**Committee of Experts on the Transport of Dangerous Goods  
and on the Globally Harmonized System of Classification  
and Labelling of Chemicals**

**Sub-Committee of Experts on the  
Transport of Dangerous Goods**

**Proposed corrections to the 6th revised edition of the Manual  
of Tests and Criteria**

**Note by the Secretariat**

**20. Section 38.3, paragraph 38.3.4.2, Figure 38.3.4.2**

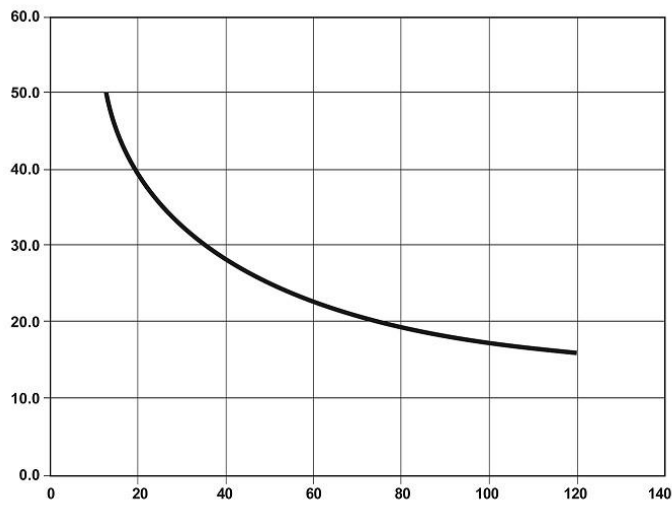
Replace the existing figure with the following (the legend of the axis remains unchanged)
